Network Camera Firmware Version: V5.8.20 Release Note

Firmware Basic Information	Firmware Version:	V5.8.20 build 230309
		V5.8.20 build 230328
		V5.8.20 build 230522

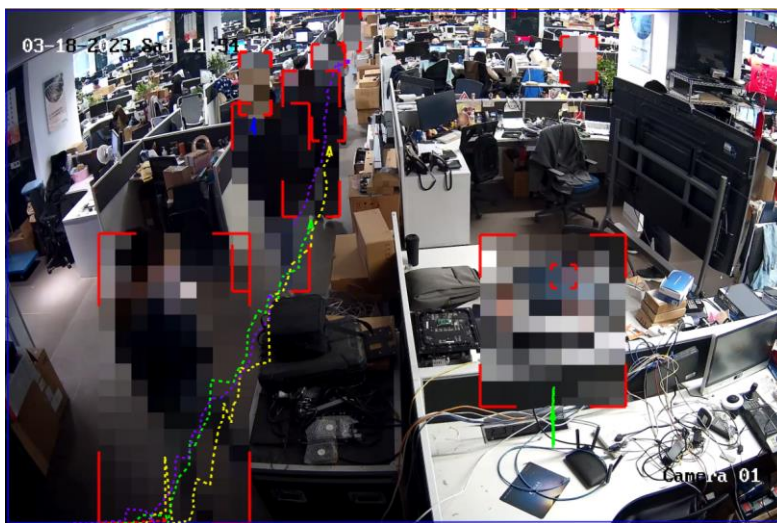
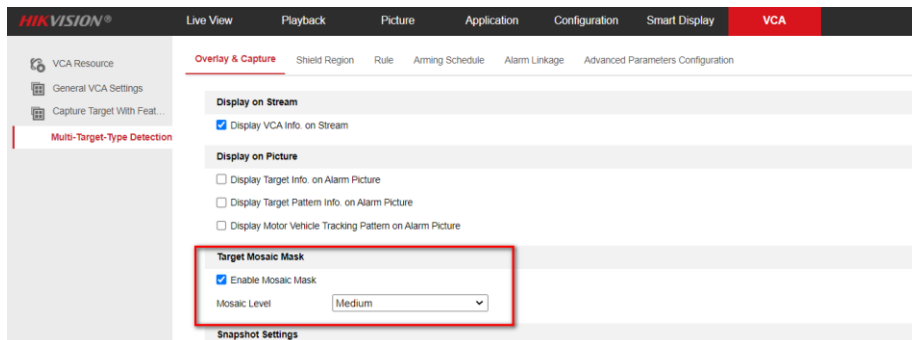
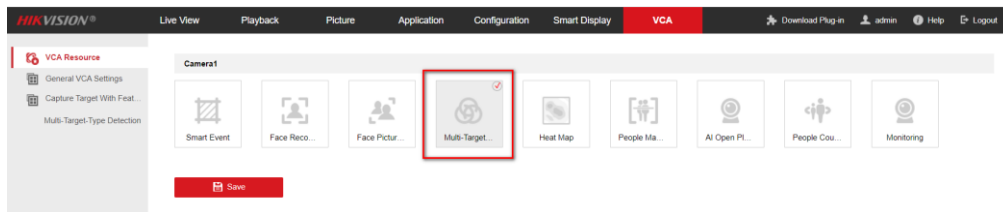
- Support Target Mosaic Mask function on Multi-Target-Type Detection mode (Only supported by 2MP and 4MP non-ANPR model (without /P)) .

Enter VCA - Multi-Target-Type Detection – Overlay& Capture- Target Mosaic Mask to enable it.

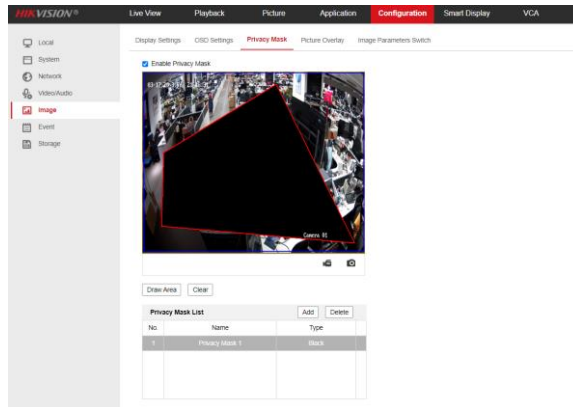
- Support drawing polygon 4-sides area of private mask.

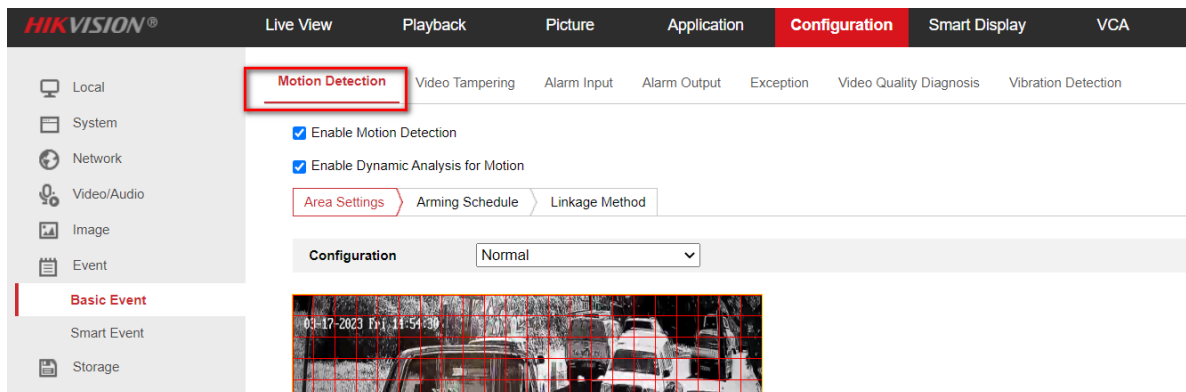
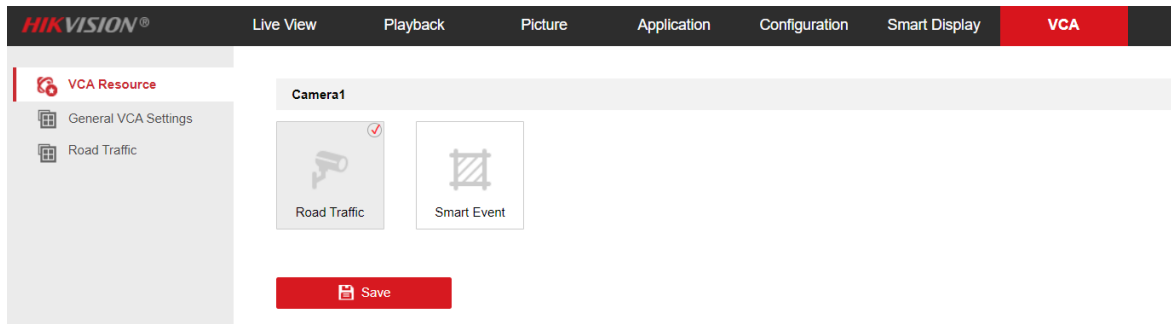
- Third Stream support NPQ (Smooth Streaming). When Smooth Streaming is enabled, functions such as, variable bitrate, MJPEG, SVC, EPTZ, and Target Cropping, are not supported.

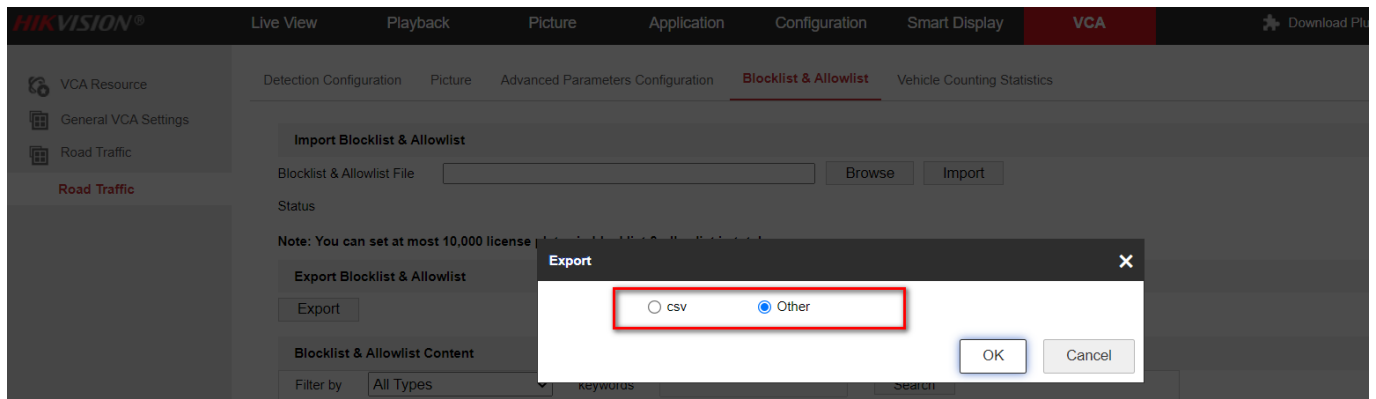
- Support motion detection on Road traffic mode. (Only supported by ANPR model (with /P))

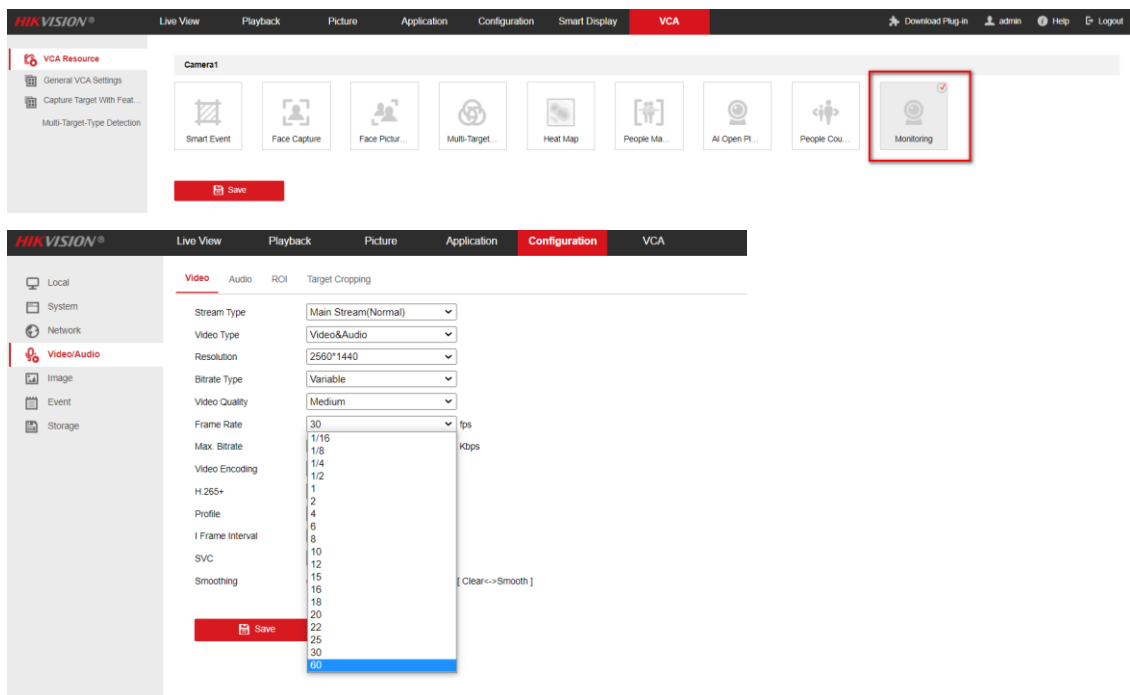
- Support high frame rate on monitoring mode.(Only supported by 2MP and 4MP model)
